City of Mississauga Department Comments

Date Finalized: 2023-07-12 File(s): A233.23

Property Address: 1050 Deborah Drive

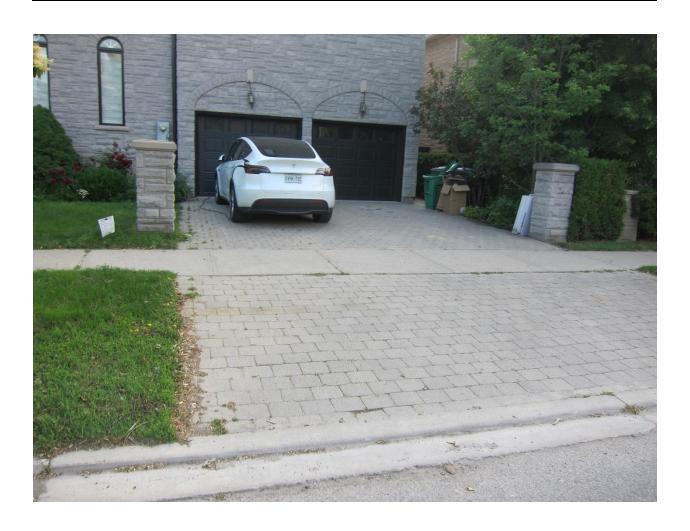
Enclosed for Committees easy reference are photos of the existing driveway. Our Traffic Planning Section does not support the proposed driveway widening as it will not meet the minimum corner separation clearance as per the Transportation Association Canada Geometric Design Guide for Canadian Roads guideline at Ogden Avenue.
